From: [Keyon, David](#)
To: [Gerry Haas](#); [Andy Wang](#)
Cc: [Bethany Windle](#); [Hill, Shannon](#); [Downtown West Project](#)
Subject: Re: Downtown West review
Date: Tuesday, April 13, 2021 5:57:52 PM
Attachments: [BOSTON PROPERTIES Final SSE.pdf](#)
[App B-2 Riparian Setback Assessment.pdf](#)

CONDITION 11 EXCEPTION REQUEST

Date	April 5, 2021
Subject	Stream and Riparian Setback Condition (Condition 11) Exception for South Almaden Office Project (Boston Properties), City of San Jose (#SP20-005)
Recommendation	No Recommendation
Reviewed By	Gerry Haas, Conservation Planner

Subject: Biological Assessment Regarding Presence / Absence of Riparian Habitat, Delmas Mixed Use Project Site, San José, California

Figure 1. Site Map

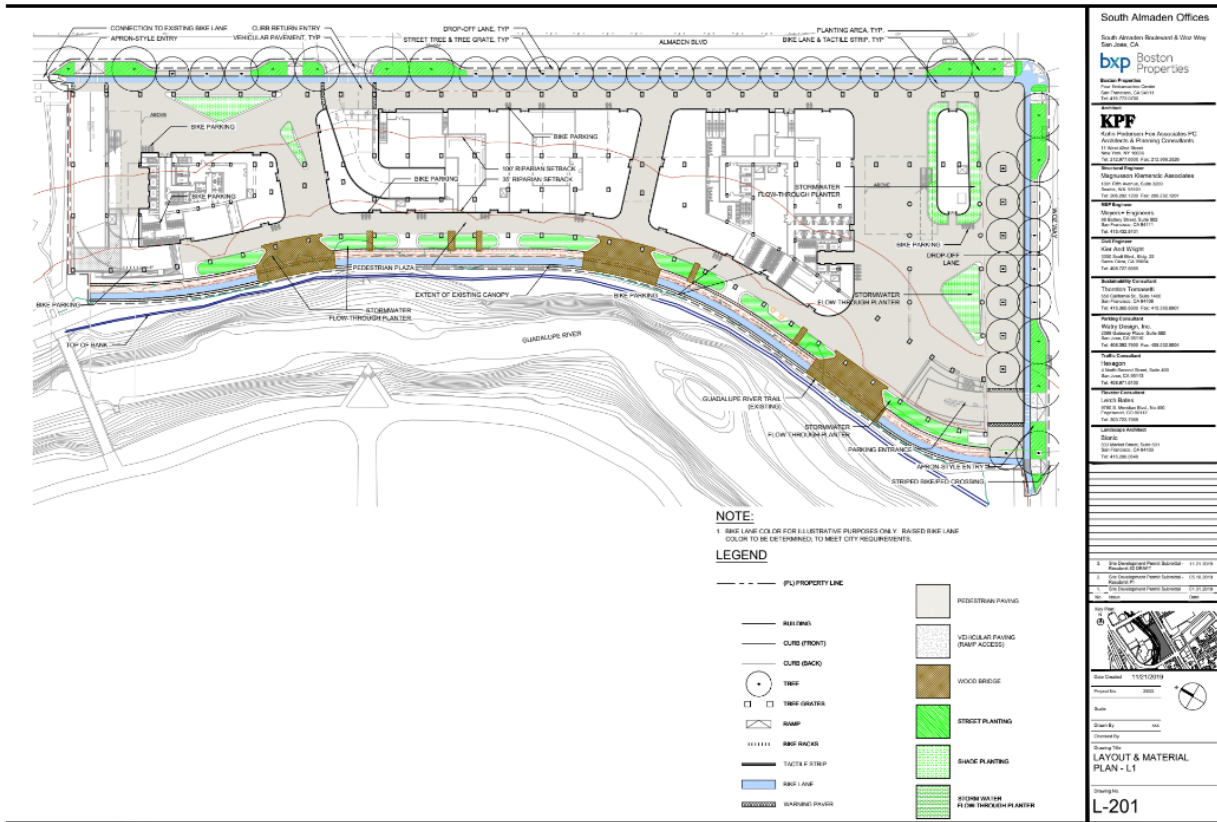
The property is currently developed with a City owned asphalt parking lot located adjacent to the Guadalupe River and Guadalupe River Trail easement immediately west of the project site. Based on the conceptual plans and aerial images, it appears the existing parking lot extends to the west property line of the site, meaning the entire parcel is currently developed with impervious surfaces. The Project proposes demolition of the existing parking lot and subsequent construction of an office/commercial building with underground parking. The footprint of the proposed building will occupy all existing developed areas of the site with a stream setback distance of as little as 0-feet from the edge of the riparian corridor. Based on the Layout & Material Plan (L-201), it appears several wood bridges/viewing platforms, pedestrian and restricted fire access paths, landscaping, bioretention areas, and proposed upgrades to the Guadalupe River Trail are proposed on the parcel and within the existing Trail easement. It is unclear whether these proposed features extend further into the setback area than does existing development.

As proposed, the majority of this project would not be subject to the Habitat Plan because it will not affect new land cover. The only feature that appears to be covered by the Habitat Plan is an off-site bridge extending from the proposed building to the opposite bank of Guadalupe Creek. This feature would be covered by the Habitat Plan and would be subject to land cover fees if constructed.

Based on the conceptual plans and information provided for the Stream Setback Exception request, it appears the existing pavement extends to the property line and the proposed development would *not increase impervious surface area* within the required minimum 35-foot Stream Setback. The lone exception to the redevelopment within the existing footprint would be a bridge stream crossing providing a means of access to the parcel. Because this particular feature is exempt from Condition 11 there is no need for a stream setback exception request. And because the remainder of the site is not subject to Condition 11 by virtue of no new impacts to land cover, the entire project is not subject to Condition 11, and a Stream Setback Exception Request is not required by the Habitat Plan.

Figure 3. Topographic Top of Bank Boundary, Delmas Mixed Use Project Site, San Jose, CA

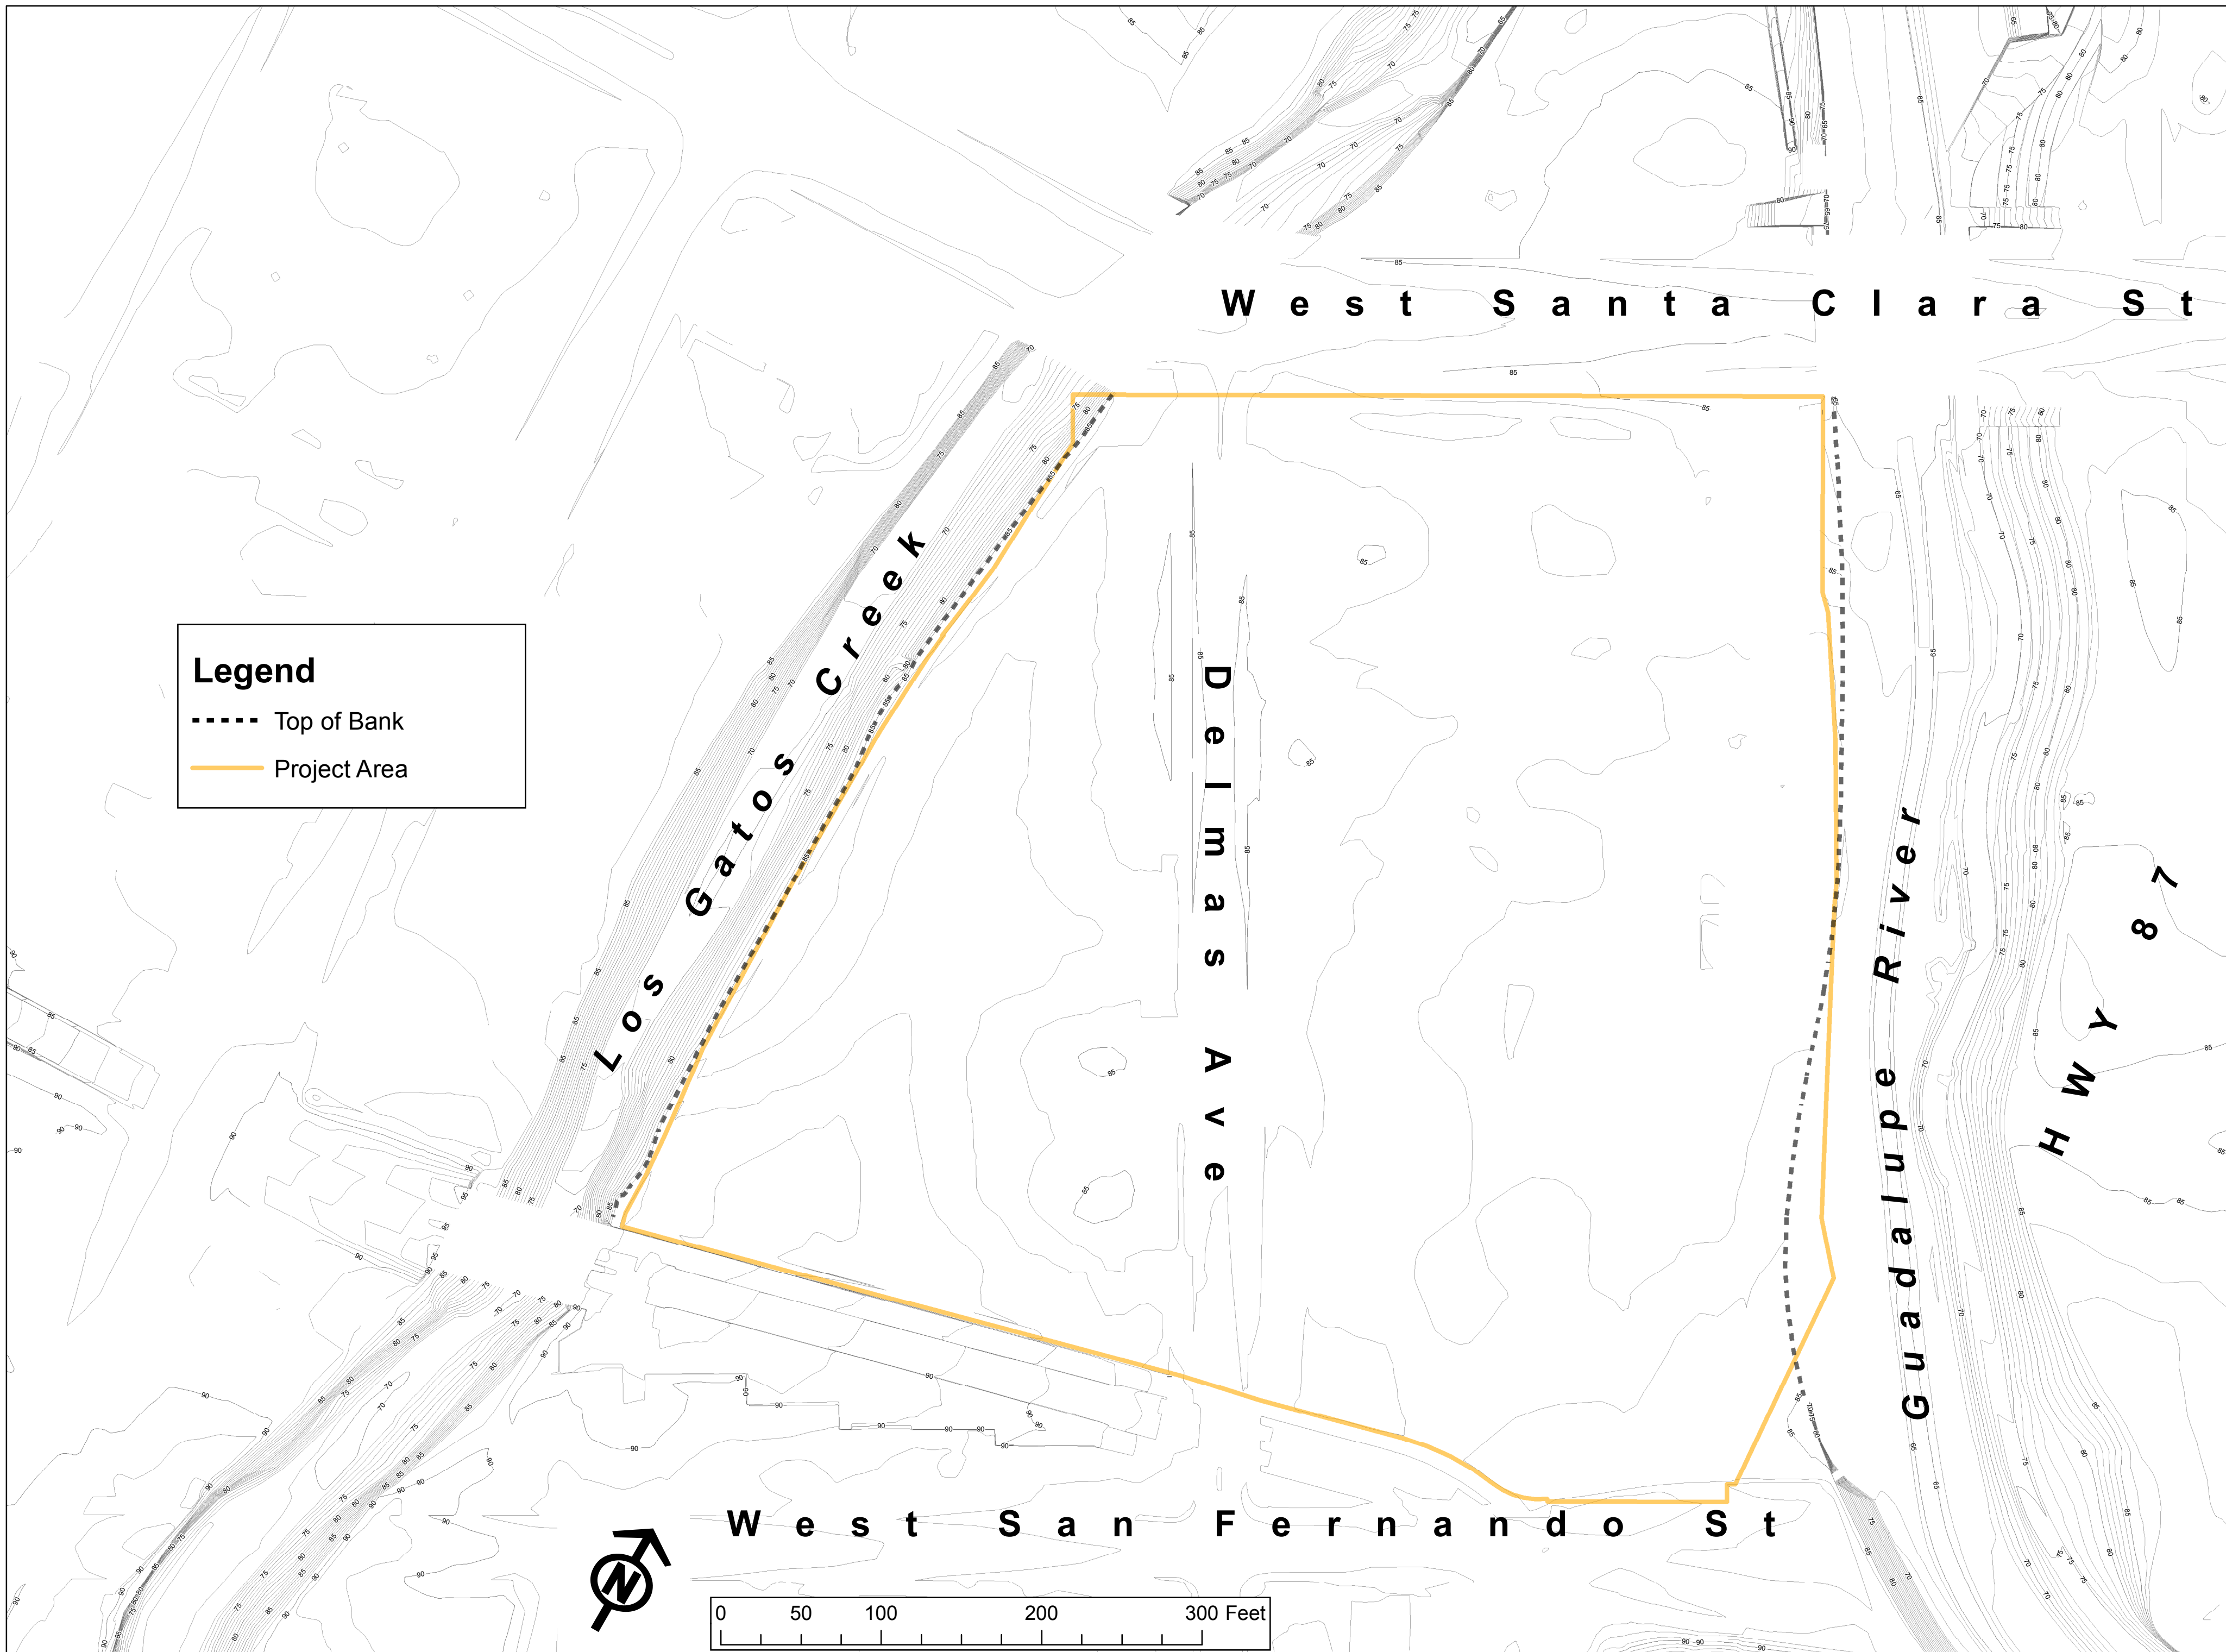
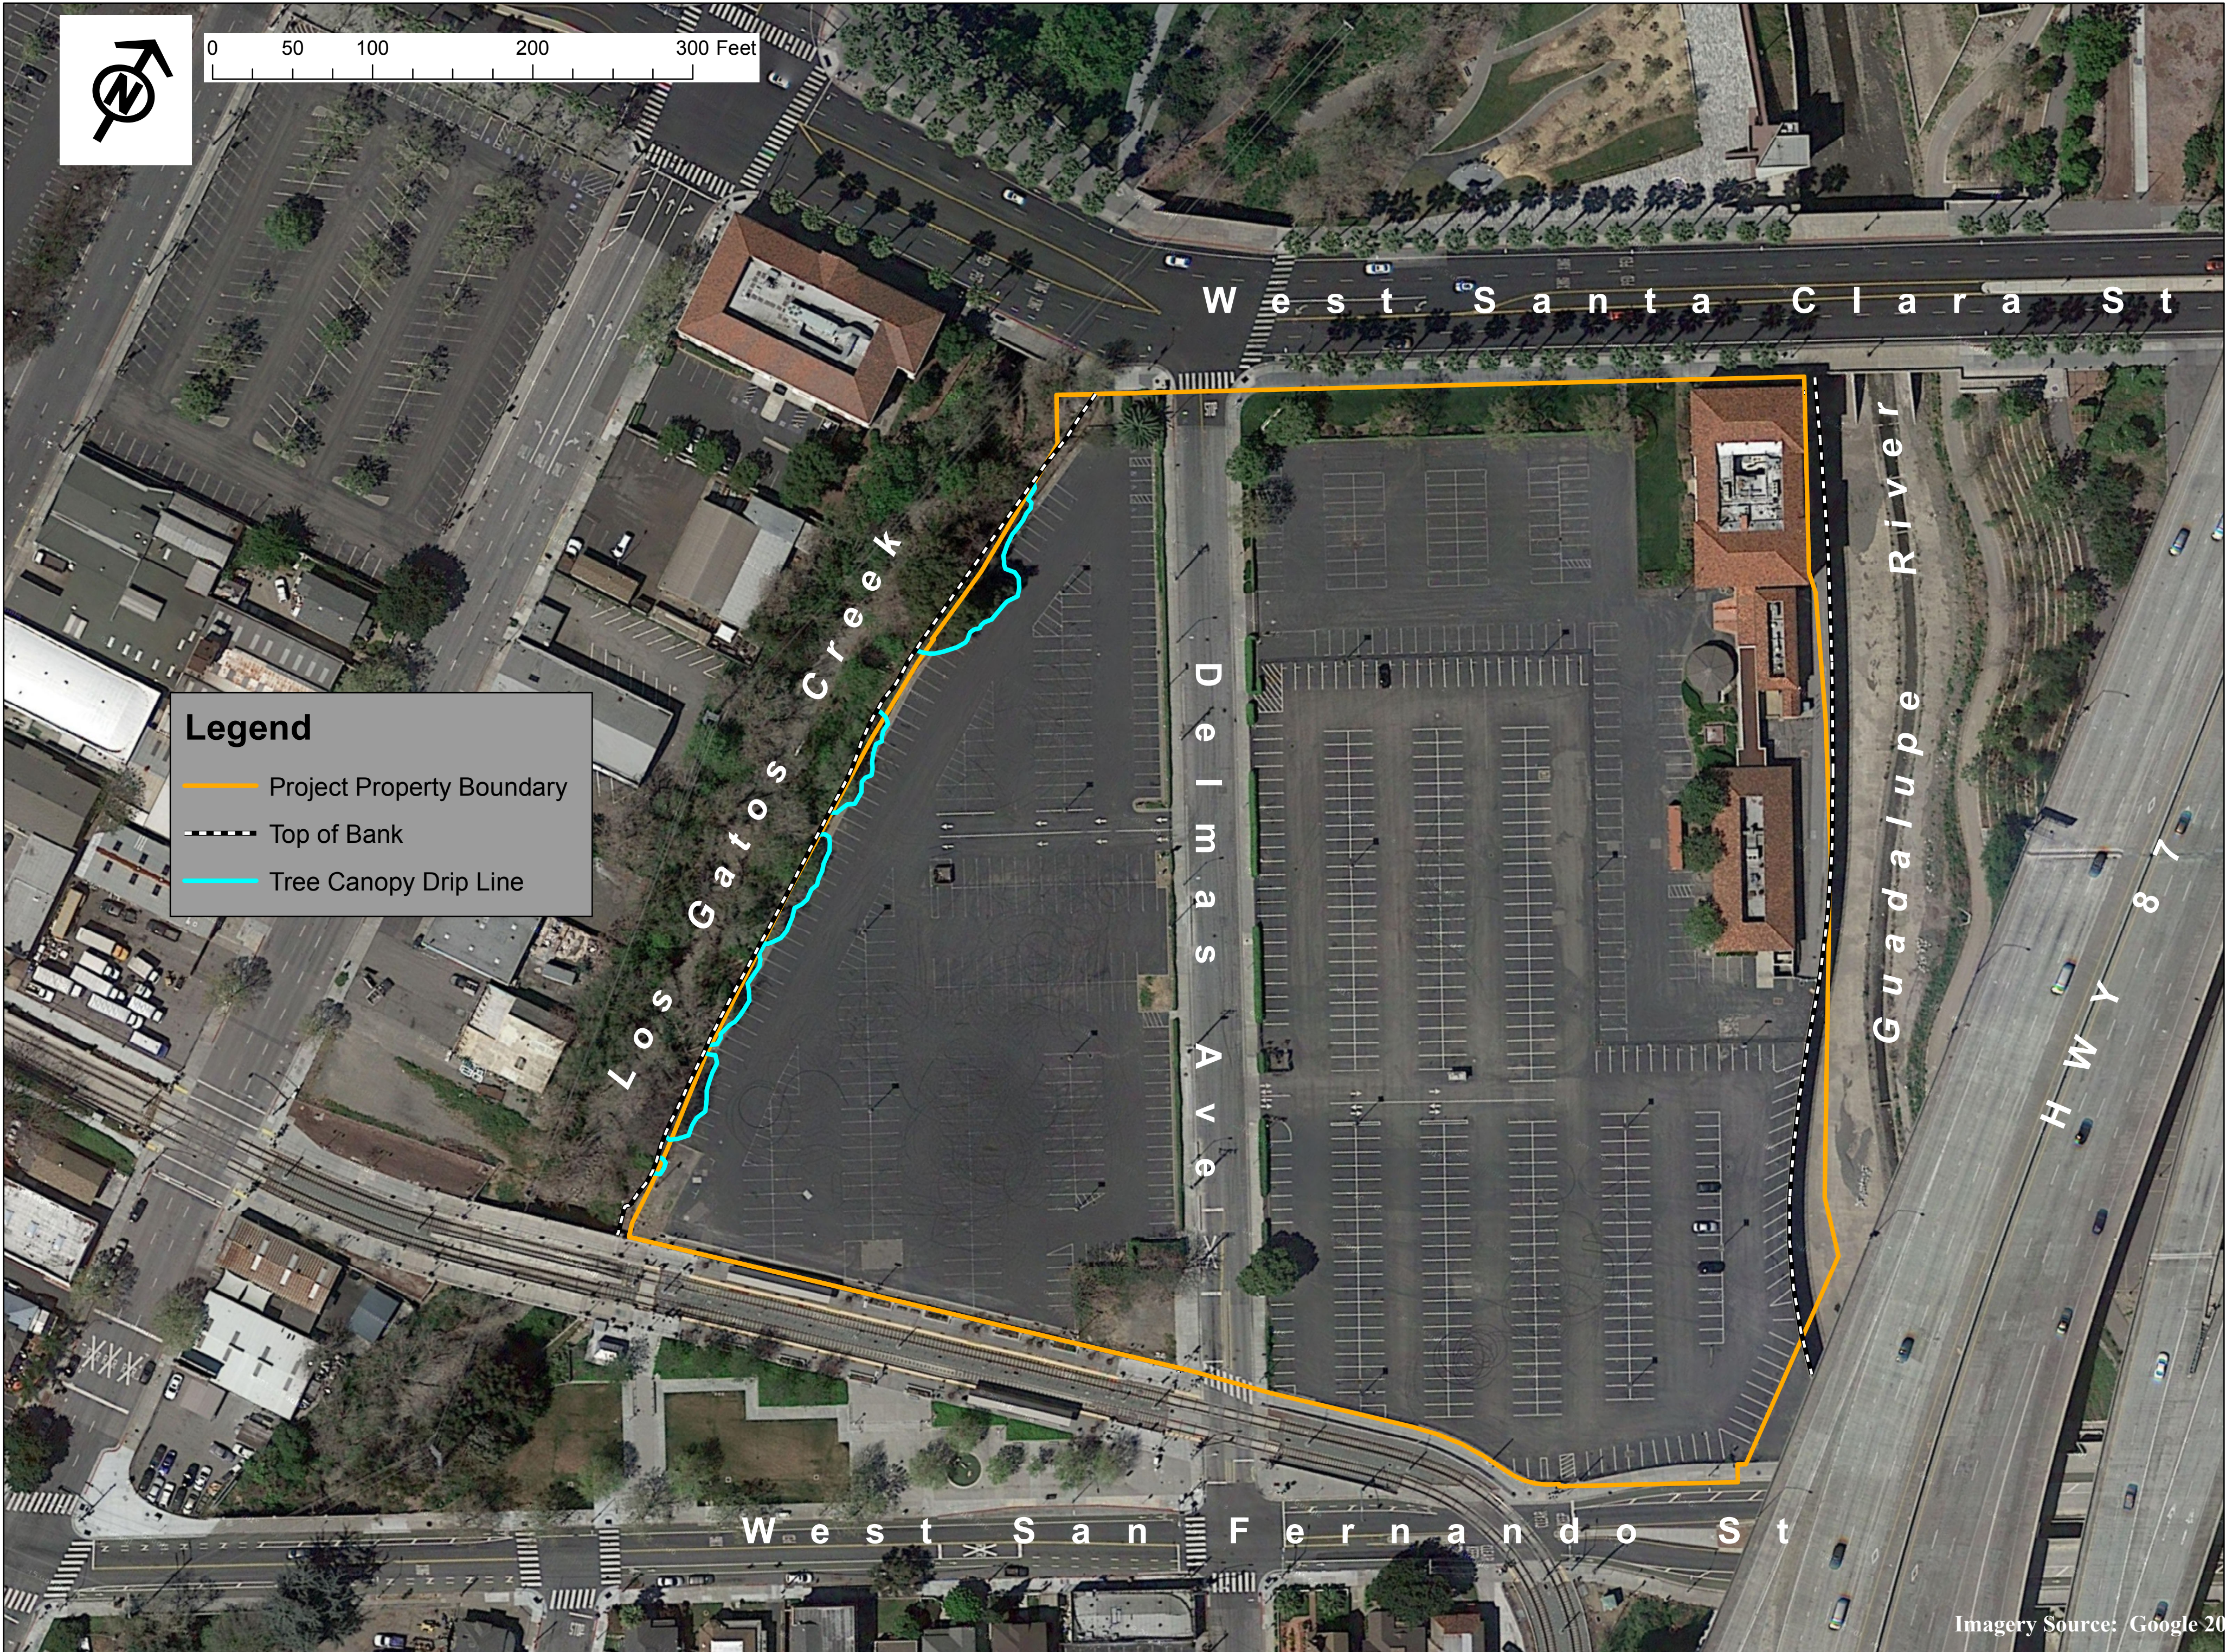
Top of Bank and River Spillway Elevation Data. Huffman-Broadway Group, Inc. (HBG) completed a biological top of bank study at the Project Site in August 2015 (HBG 2015) and concluded that the top of bank onsite for the Guadalupe River is the top of the retaining wall at

the 85-foot NAVD 88¹ contour line (see Figures 3 and 4). No evidence of wetlands or other water bodies was observed onsite.
